pd-trigger — Design Document

ai-ee v1 pipeline

Board review (P8 adversarial) - pd-trigger

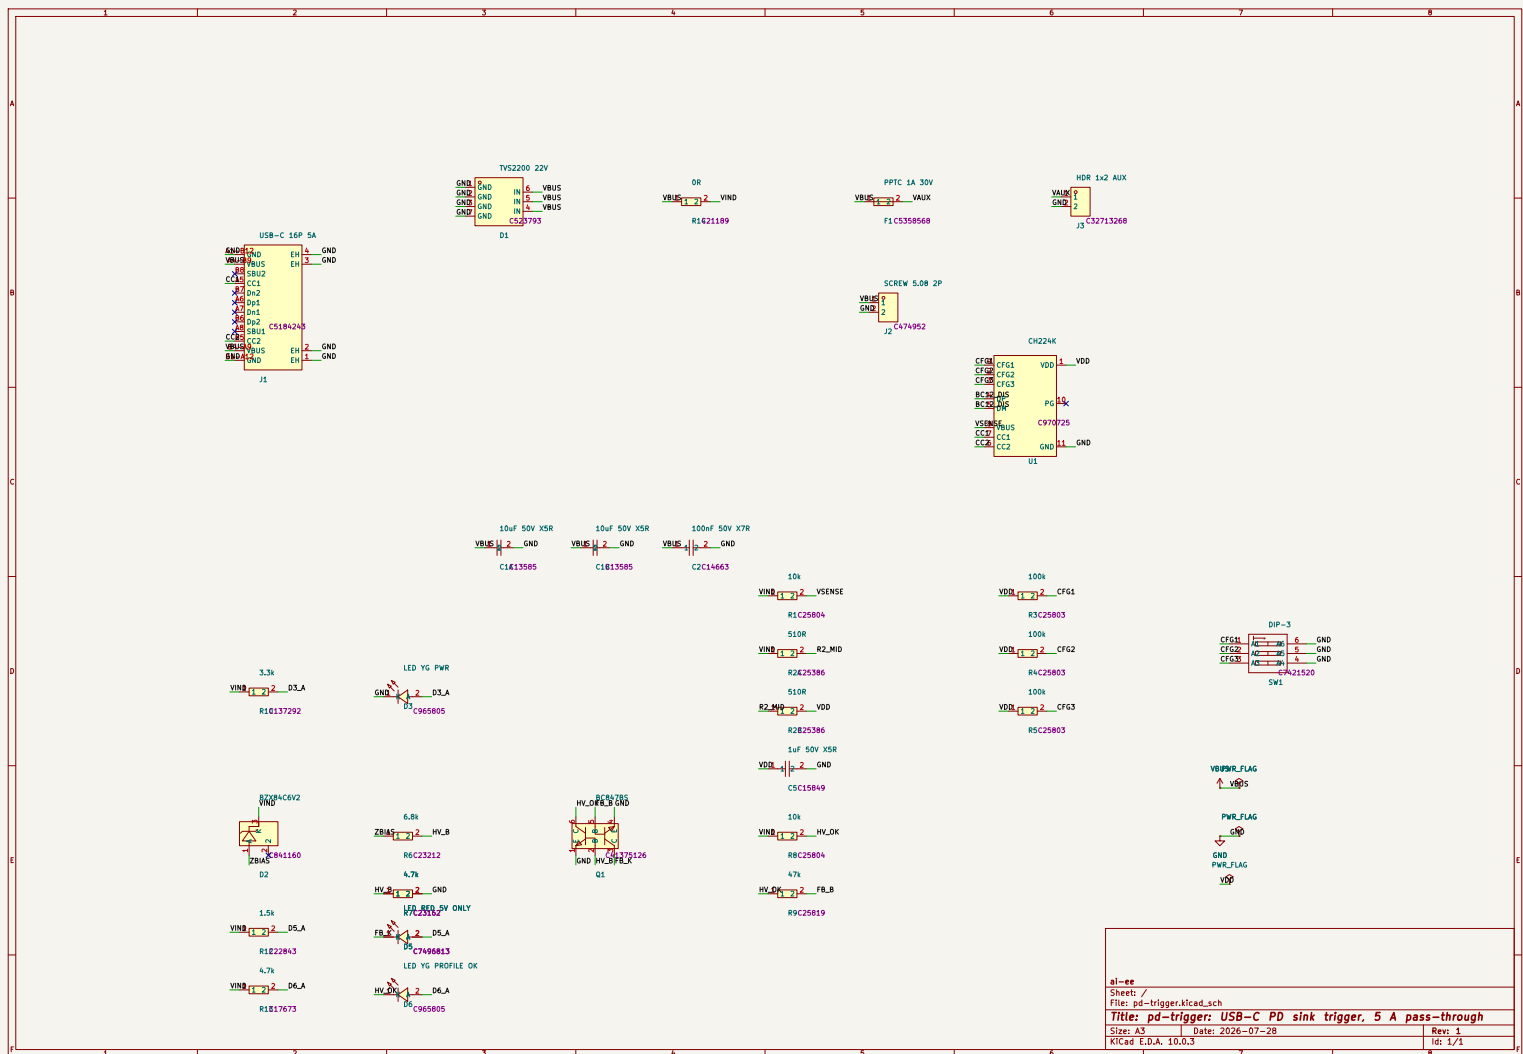
W1 `dp-dm-short-at-chip`: architecture’s PD-only short (`/BC12.DIS`) ACCEPTED by the reviewer as hardware-SAFER than the datasheet’s connector wiring (removes a 21V-onto-3.8V-abs-max fault path). Cost: no QC/BC legacy support - the board is “PD sources only”; goes on B.SilkS + order docs. W2 `vdd-worst-corner`: true worst case 0.979mA at 4.4V low-line all-straps- closed vs unpublished CH224K IDD - bounded by WCH’s own reference circuit; V1 bring-up step: measure VDD at the 5V profile; contingency = both 510R -> smaller (documented floor 600R total). Bring-up addenda: buzz out Q1 E/B/C once (clone PDF JS-gated; Nexperia- standard pinning verified as the compatibility claim).

reports/render_final/top.png

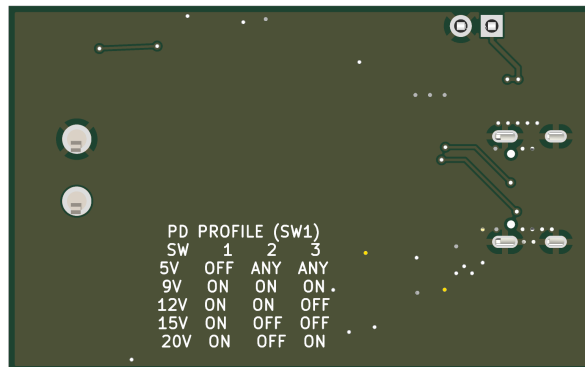
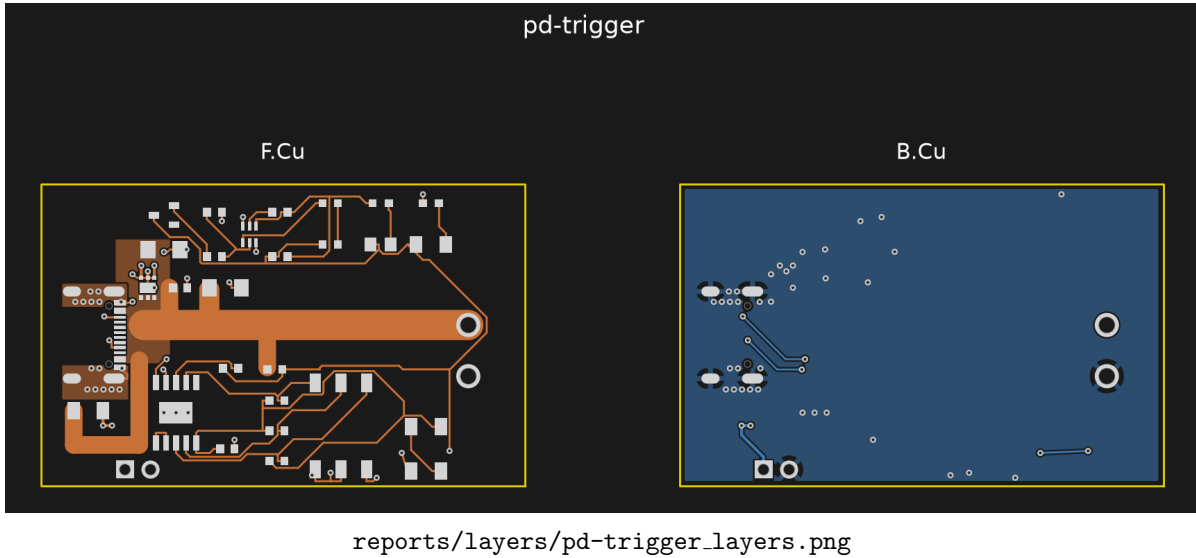
E1 - 5 A return chokes at J1's GND contact pads (error, checker-blind by design D7)

The 4 GND cable contacts land on two merged SMD pads (F.Cu only): A1-B12 at (17.63,39.31) and B1-A12 at (17.63,45.71), nominally 2.5 A each at the 5 A rating. Their ONLY copper into the B.Cu return pour:

- A1-B12 (top): a 0.2 mm wide, 2.7 mm long F.Cu chain (3 segments) into shell pad 1's THT barrel, plus one 0.6/0.3 via whose annulus grazes the pad corner by ~0.05 mm (etch-tolerance-level). 0.2 mm at 2 oz = 0.80 A capacity at 10 C rise (pipeline model); at 2.5 A the same model gives ~133 C rise (short-neck heatsinking will moderate this, but it is a >3x overcurrent on the model's own terms). ~13.6 squares = 3.3 mohm.
- B1-A12 (bottom): a 0.2 mm x 1.3 mm trace into ONE 0.6/0.3 via. The board's own via budget (constraints via_amps 0.5) says 2.5 A needs 5 vias; there is 1. Shell pad 4 sits 0.32 mm away but is NOT connected on F.Cu - its copper does not help.

Architecture D7/power_tree structural requirement ">= 10 vias at J1's GND pads" (the stated substitute for keeping GND out of power[] so check_current stays quiet): not delivered. DRC cannot see it (0.2 mm is netclass-legal), check_current cannot see it (GND undeclared), check_return_path no-ops (no high_speed key). Failure mode: sustained 5 A at any profile heats the two necks far past the 10 C design intent; long-term trace/joint fatigue, intermittent ground, and full return current cascading onto the surviving 0.2 mm chain. Fix is cheap at P9: an F.Cu GND spandrel bonding each contact pad to its shell pad (the VBUS pour top edge is at y 39.7 - the strip above it, and the strip x < 17.2 plus the region south of y 46, are free) plus 4-5 vias per side.

E2 - Safety/waiver silk markings absent (error, promised artifact) Board-wide gr.text count is ZERO; B.SilkS carries nothing at all (both B.SilkS references in the file are the stackup layer table). Missing, each one a written promise:

- AUX 1A MAX + V+/GND at J3 (P0 answer 4 "silk-marked", V10). F1 makes overload safe-by-hardware, but polarity of the 2-pin aux header is unmarked.
- PD SOURCES ONLY (ERC waiver W1's standing condition: "goes on B.SilkS + order docs"). The waiver's silk half is currently unfulfilled.
- J2 screw-terminal polarity. Trunk lands on J2 pad 1 = the LOWER screw (board-bottom side); nothing anywhere tells the bench user which screw is V+. Reverse-wiring a load on a 100 W output is the single easiest field mistake this board can cause.

E3 - User-interface silk absent (error, promised artifact)

- The five-row profile table on B.SilkS - D3 calls silk "the user interface" and specifies the table verbatim; the bottom is a clean pour with room. Without it the ON/OFF-to-voltage map exists only off-board; a user WILL set 9 V expecting 12 V by trial and error. (Fail-safe floor: any wrong guess >= the 5 V fallback, and OFF-fail = 5 V - the mistake is bounded but real.)

- LED legends PWR / 5V ONLY / PROFILE OK (D4/V10): the render shows refdes D3/D5/D6 only. The entire P0-answer-6 "visible fallback indication" scheme is mute without the words - a lit red LED labeled "D5" indicates nothing.

W1 - J1 mouth recessed ~0.4-0.5 mm behind the board edge (warning, flagged at P6) Courtyard/silk front edge $x = 10.18$ vs board edge $x = 9.8$. USB-C receptacles are normally flush-to-overhanging; a recessed mouth lets thick/molded plug overmolds butt the board edge and hold the plug fractionally short of latch - intermittent CC, no PD, "works with some cables". On a bare bench board with arbitrary cables this is a real annoyance risk. Fix: nudge J1 -x 0.5-1.0 mm at P9 (pour edge follows; nothing else in that corridor), or accept and note in order docs.

W2 - Outline 48 x 30 mm exceeds the architecture's hard ceiling (warning, drift) Edge.Cuts = (9.8,27.51)-(57.8,57.51) = 48 x 30 mm. D9: nominal 45 x 25, "hard ceiling 48 x 28 mm"; 30 mm violates D9's own ceiling by 2 mm even though it equals P0 answer 5's literal +20 % (40x25 -> 48x30, +44 % area vs the brief's target). No digest discloses the growth past D9. Consequence is cost/footprint only, but it must be disclosed to the user at the checkpoint rather than discovered.

A1 - J2 GND pad ties to the return pour through 4 thermal spokes (advisory) J2 pad 2 (THT, 2.4 mm pad / 1.6 mm drill) connects via 4 x 0.5 mm diagonal spokes = 2.0 mm total at 2 oz -> model 8 C rise at 5 A. Legal and functional, but these are the most-loaded copper necks on the whole return after E1, at a hand-soldered joint. Recommend a solid-connect override (or a short fat GND strap) at P9; zero cost. (Verified all 4 spokes present; the VBUS pad 1 island below it is barrel-tied, normal.)

A2 - F1's VBUS feed branch is 18.3 mm long (advisory, V8 letter-violation) V8/D8 wanted all five VBUS taps hugging the run with 2-3 mm stubs. D1, C1A, C1B, C2, R14 comply; F1's feed runs 8.4 + 6.5 + 3.4 mm at 1.75 mm width to the top-left corner. Width-compliant (V8's actual purpose), carries ≤ 1 A in service; only cost is ~30 mm² of extra always-live 20 V copper. No action needed; recorded as drift.

A3 - Floating 0.65 mm² GND sliver at (20.0, 28.5) (advisory, cleanup) plane_repair's own dead-island fact (0 anchors), between J3/SW1 clearances. Cosmetic / minor DFM nit; remove at P9 cleanup or accept.

A4 - /VAUX at PPTC max-non-trip current (advisory) /VAUX routes at 0.3 mm (required 0.25 at the declared 1.0 A -> 7 C). F1's worst sustained NON-trip current is ~1.8 A -> model 27 C rise on those runs until/unless the PPTC trips. Bounded, no damage threshold approached (70-80 C copper on a 20 V node); acceptable. Recorded so nobody "fixes" it blind later.

```
# P8 digest (pd-trigger)
verify PASS 8/8 first try. Fable reviewer: 4 err + 2 warn. Copper errors
REAL: 5A RETURN choked at J1 GND pads (0.2mm necks/0.80A, 1 via) - rebuilt
w/ priority-1 F.Cu GND lobes (connect.pads solid) + 15 new 0.6/0.3 vias ->
5.68A/4.70A per pad, 16 vias (D7 >=10 met). Removed 2 stitch vias 0.121mm
from THT drills - LIVE-PROVEN KiCad DRC blind spot (via-drill vs same-net
pad-drill never checked, finding 34). Silk errors: 17 texts added; agent
CORRECTED the orchestrator's B-table spec (raw CFG bits would be inverted
vs ON=GND switch reality - printed switch positions). Warns: mouth recess
-> order docs; outline 48x30 deviation recorded; C1B channels waived w/
numbers. Re-gates: drc_routed 0/0, verify 8/8. H4 AUTO-approved.
```
